DESIGN DIVISION MARKUP PLANS COMMENTS

CC4 STABILTY BUTTRESS PROJECT

ENCLOSURE 2
BUILDING AND SAFETY DIVISION MARKUP
PLANS COMMENTS
CC4 STABILITY BUTTRESS PROJECT

We have reviewed the following documents submitted by Republic Services to Public Works on October 30, 2018, for the design change of CC-4 Stability Buttress Grading and Drainage project:

DETAIL T
1" = 10'

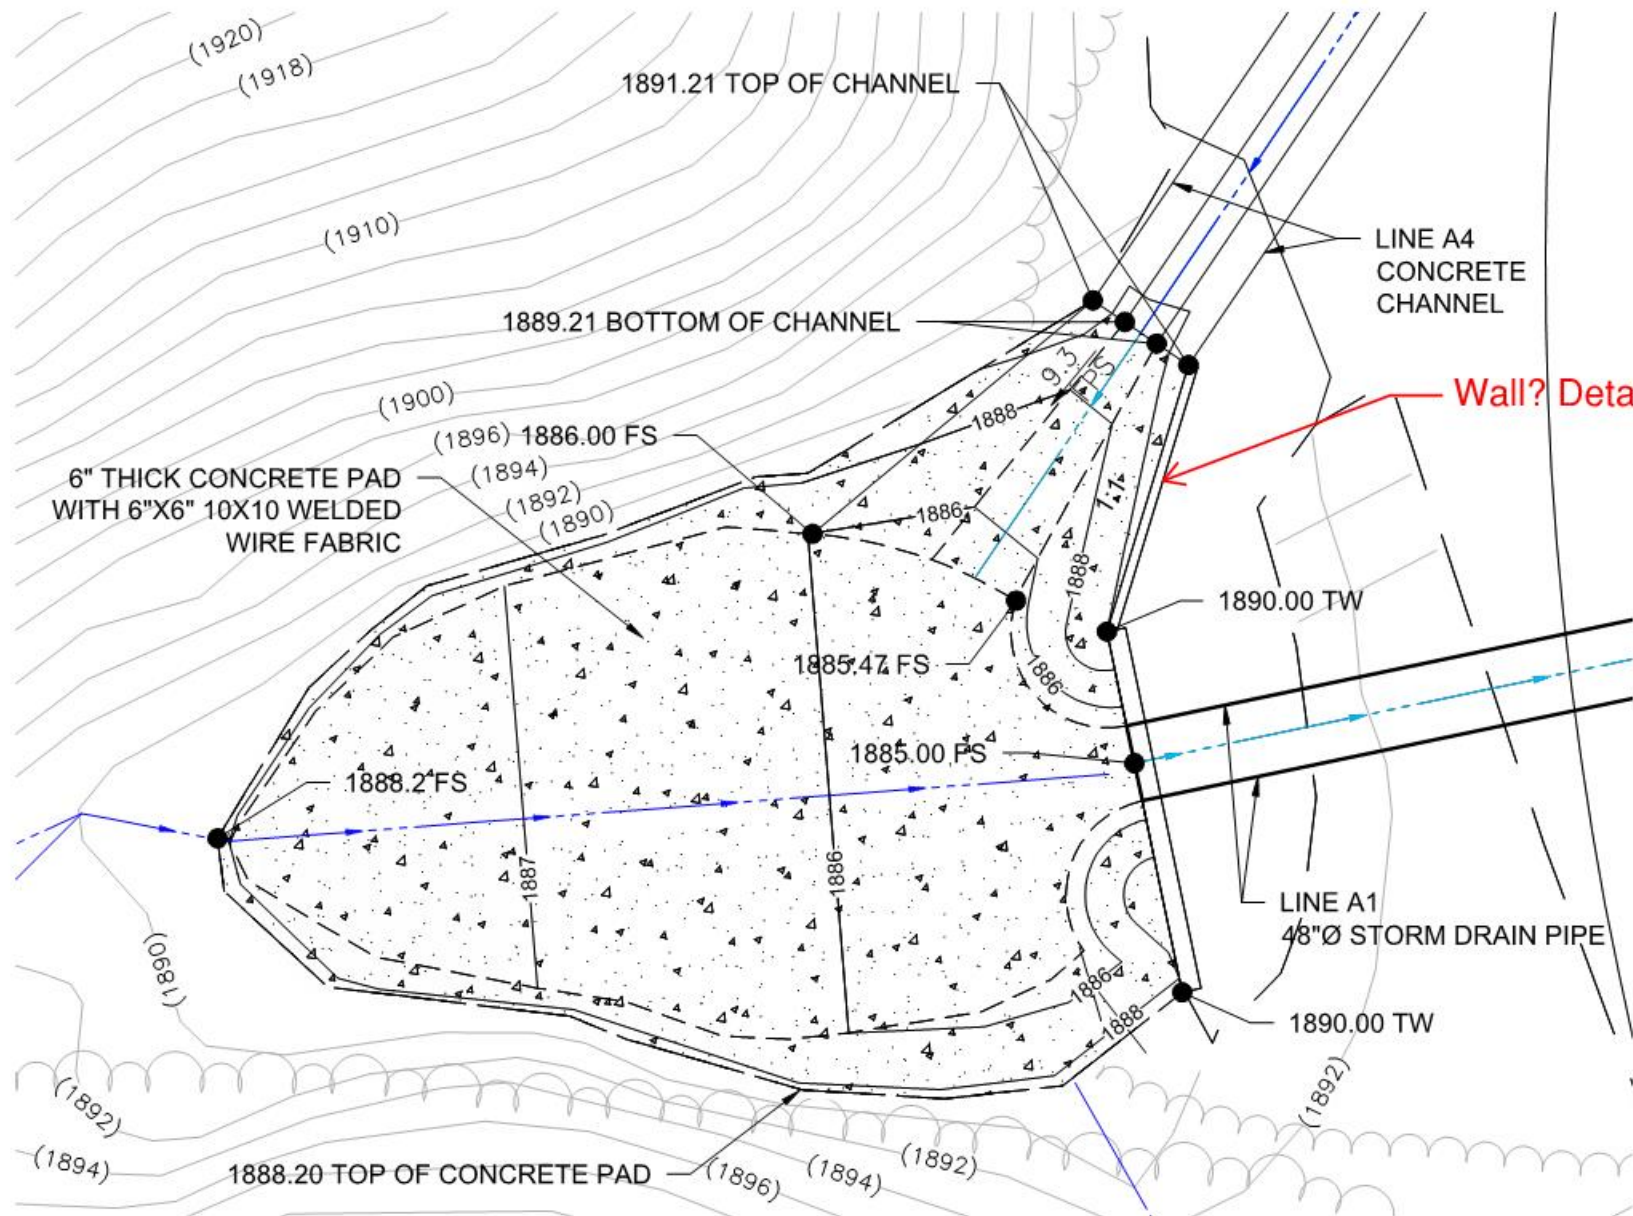
Wrong section used in WSPG run

DETAIL V
1" = 10'

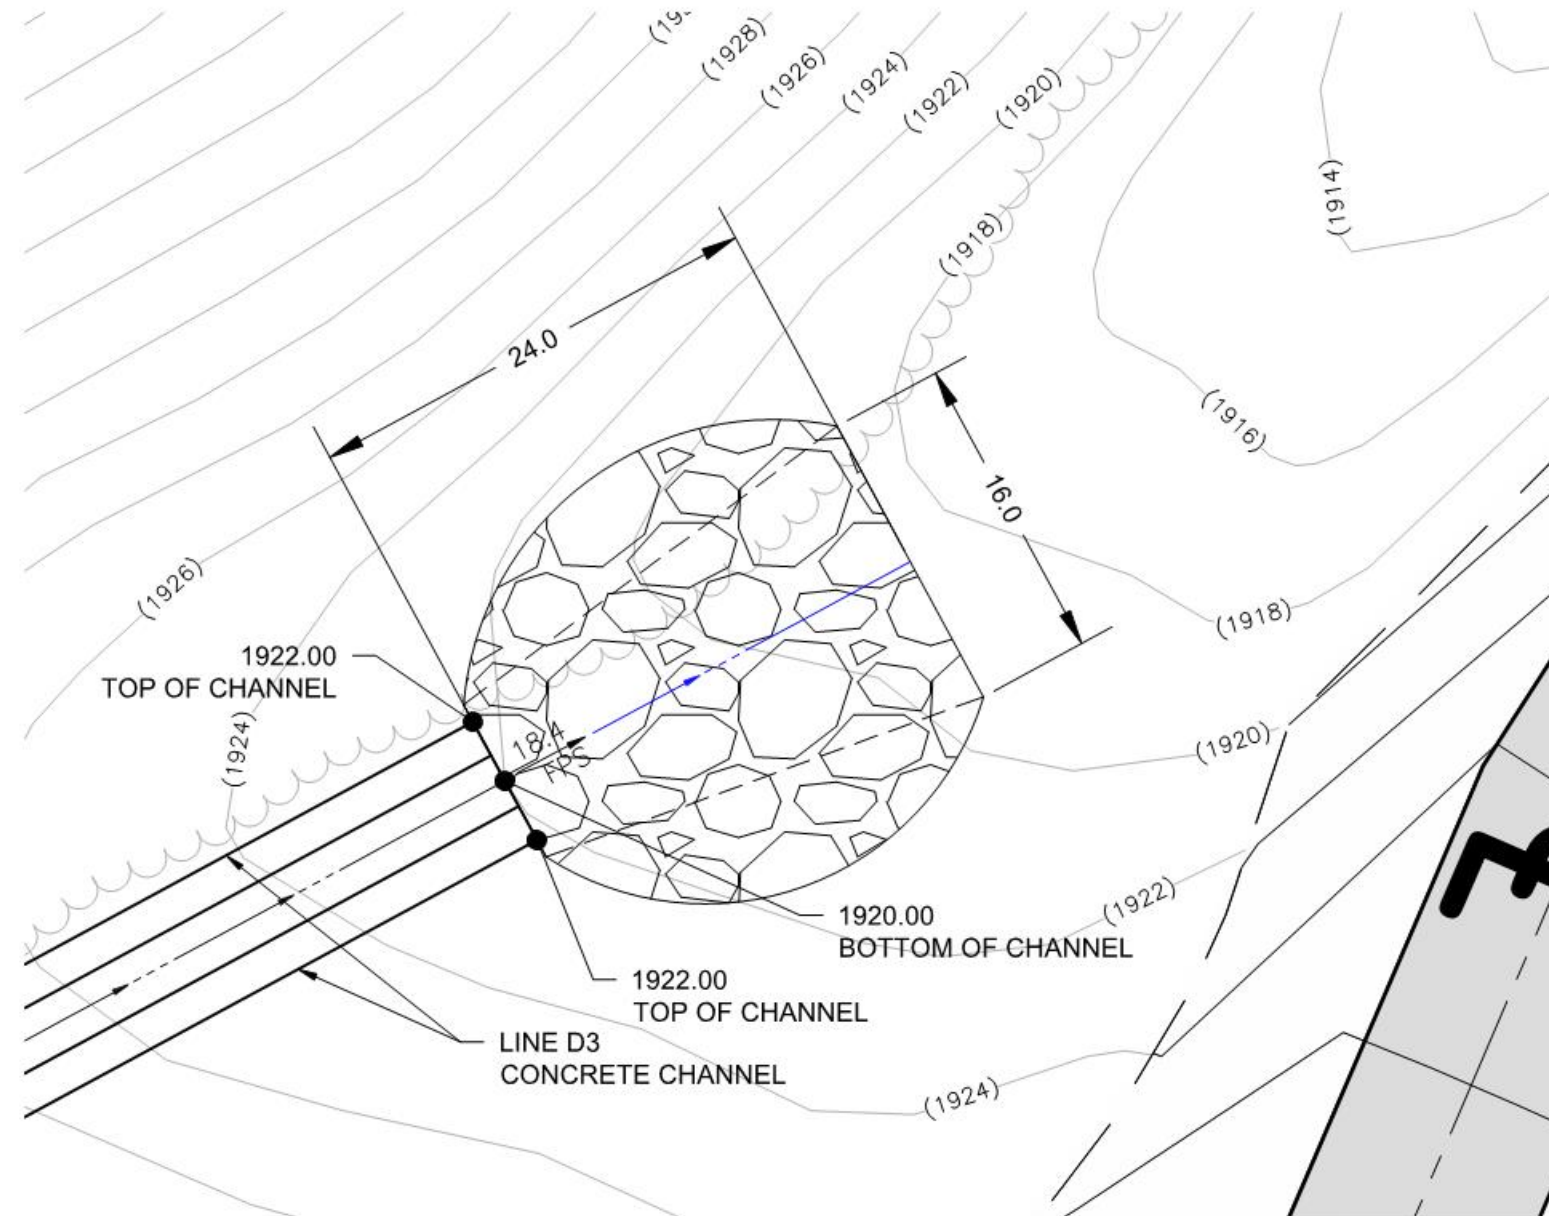
13.1 cfs per Hydrology

SUNSHINE CANYON LANDFILL
SYLMAR, CALIFORNIA
STABILITY BUTTRESS FOR CC-4
LINE D3 STORM DRAIN

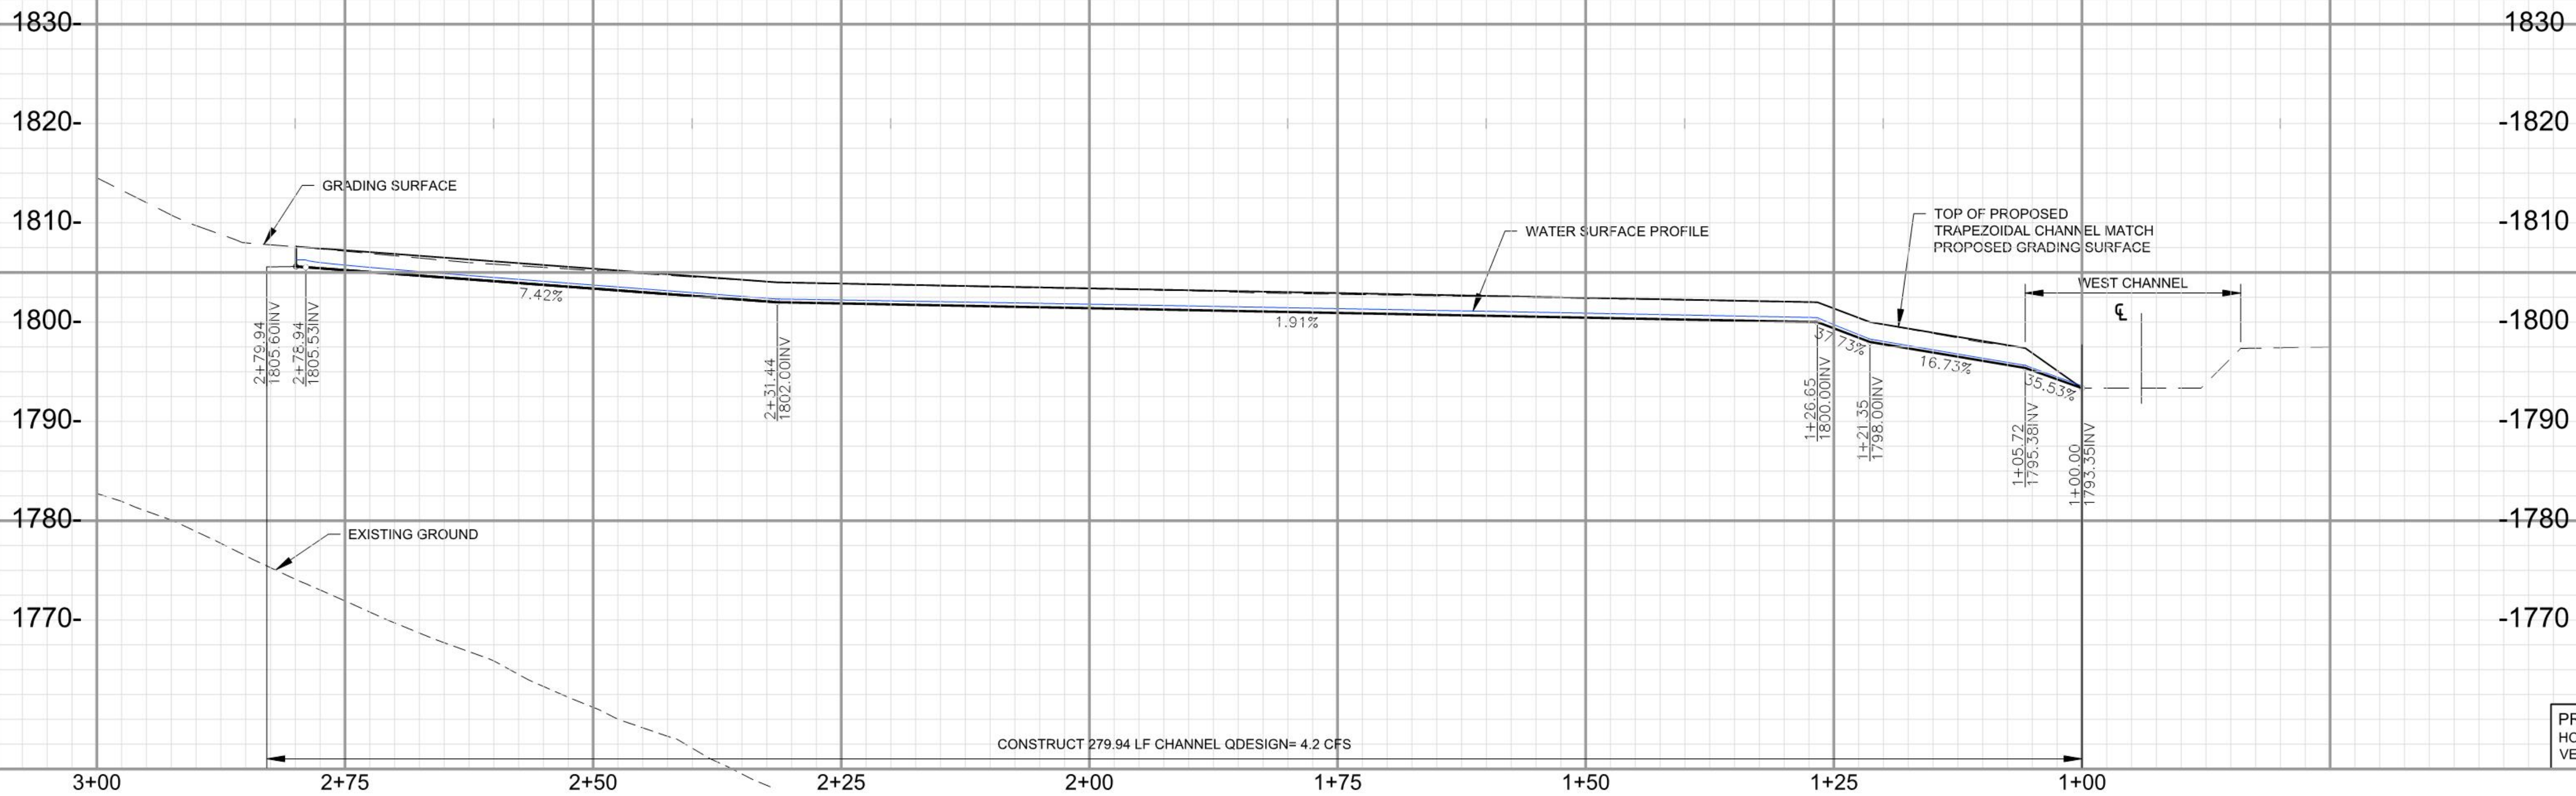
No WSPG calculations provided for this line

SUNSHINE CANYON LANDFILL
SYLMAR, CALIFORNIA
STABILITY BUTTRESS FOR CC-4
LINE B1 STORM DRAIN

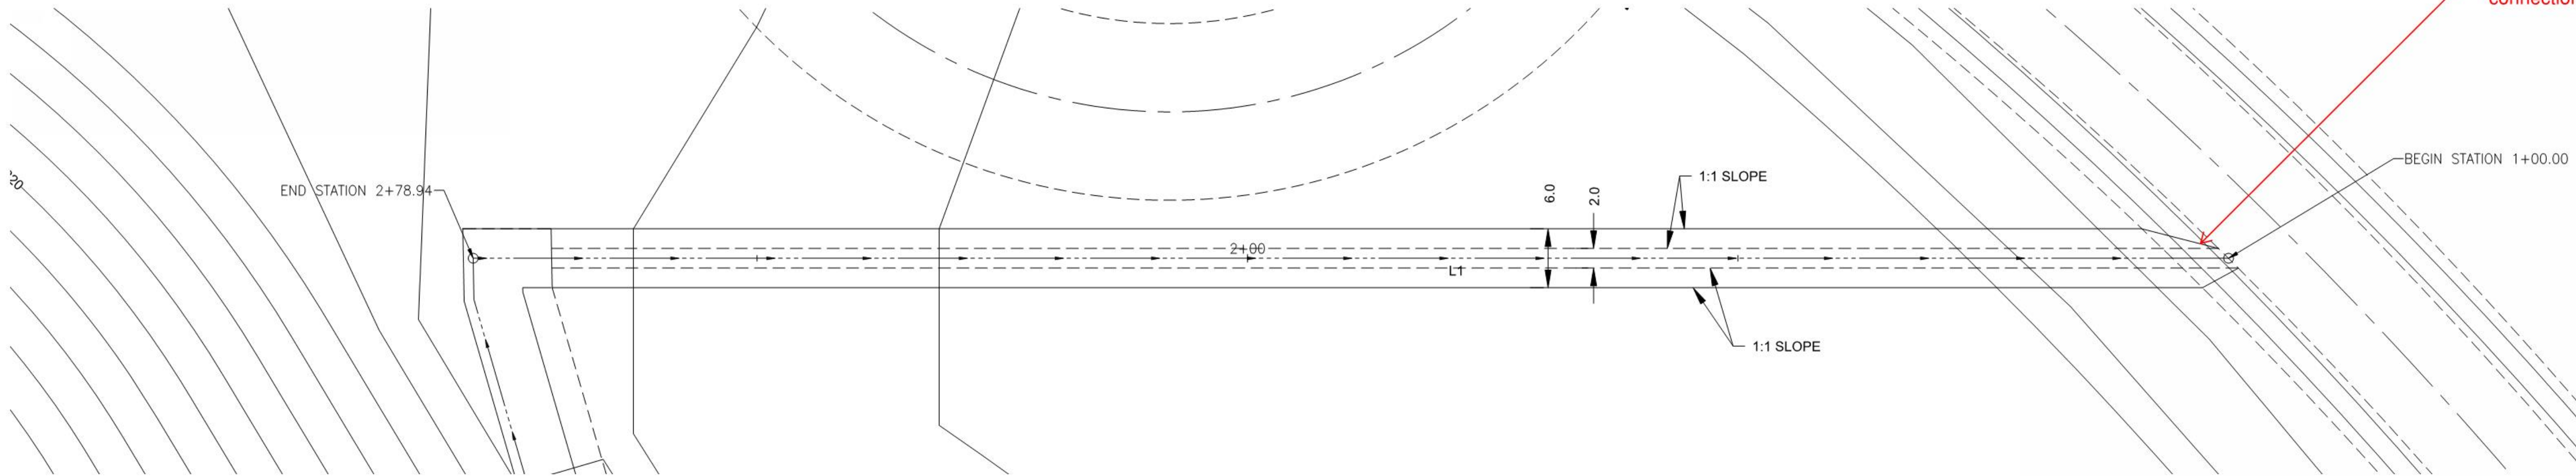
Provide channel connection details

EXCAVATION PLAN

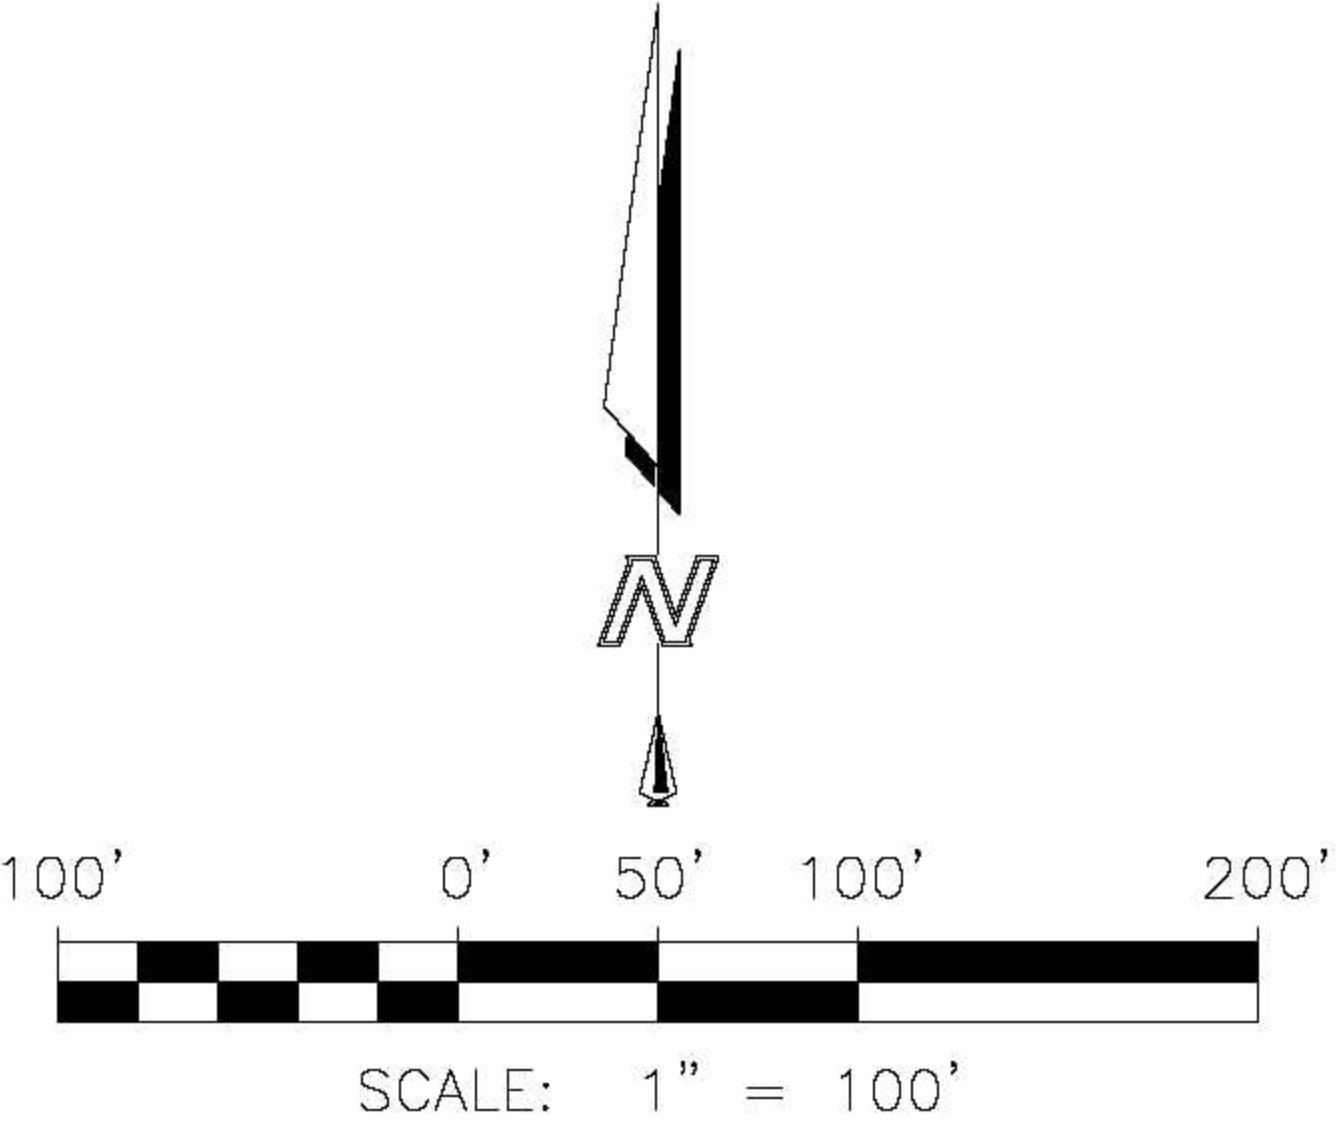
Show Required Key or Benches
on rough Grade Plans
Label All Slopes Cut/ Fill

Missed Area

SUNSHINE CANYON LANDFILL SYLMAR, CALIFORNIA STABILITY BUTTRESS FOR CC-4	DWG NO. 4B
PRECISE GRADING PLAN	PROJECT NO. S018.1103

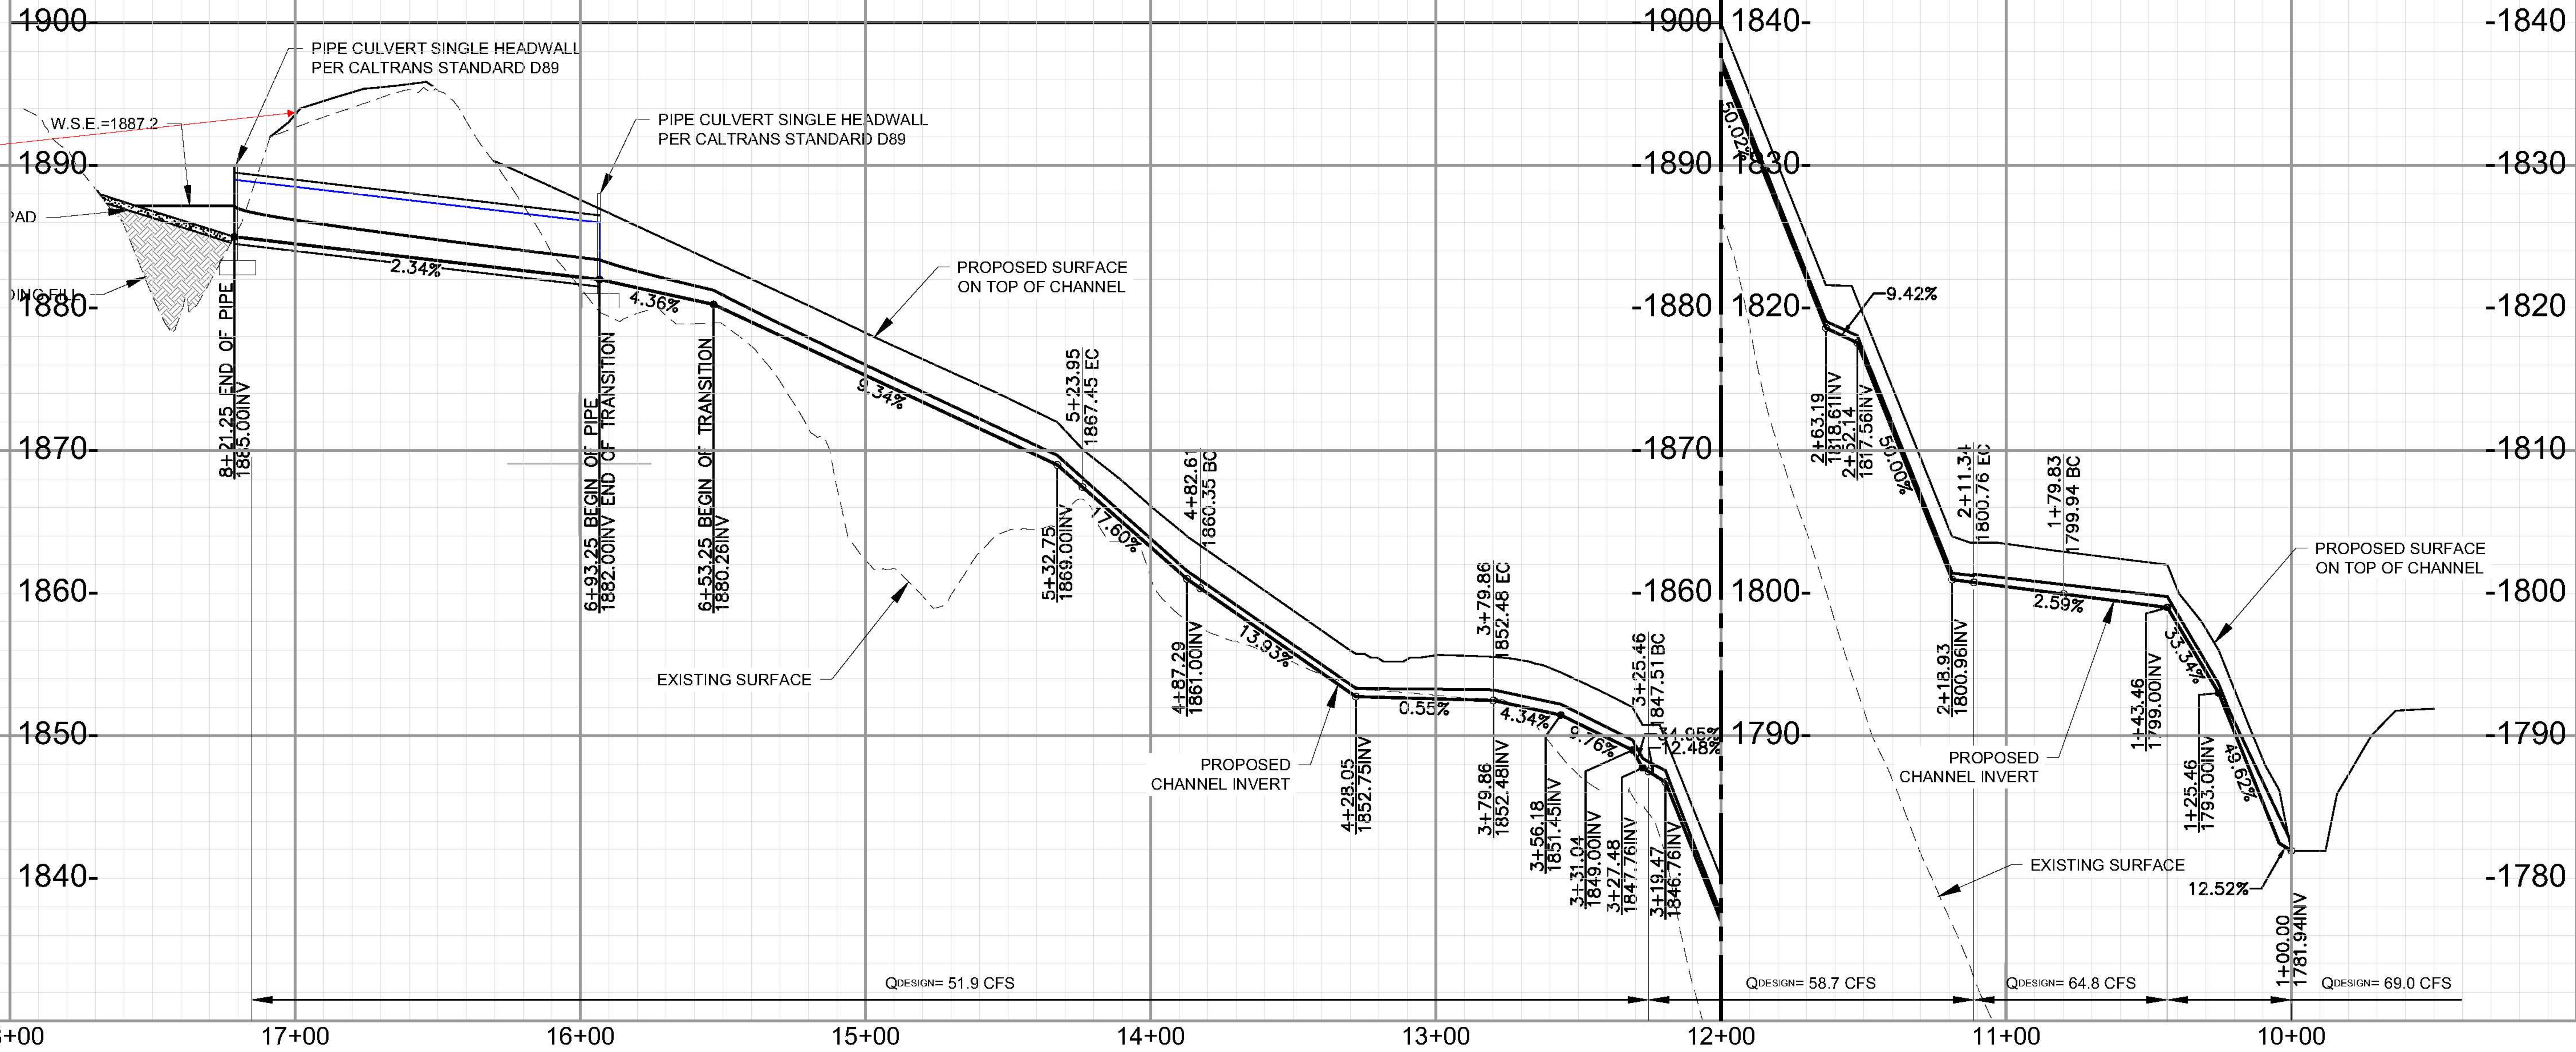
Clarify how the new extension of the SCE Tower Road goes over Line A1. See DWR NO. 8
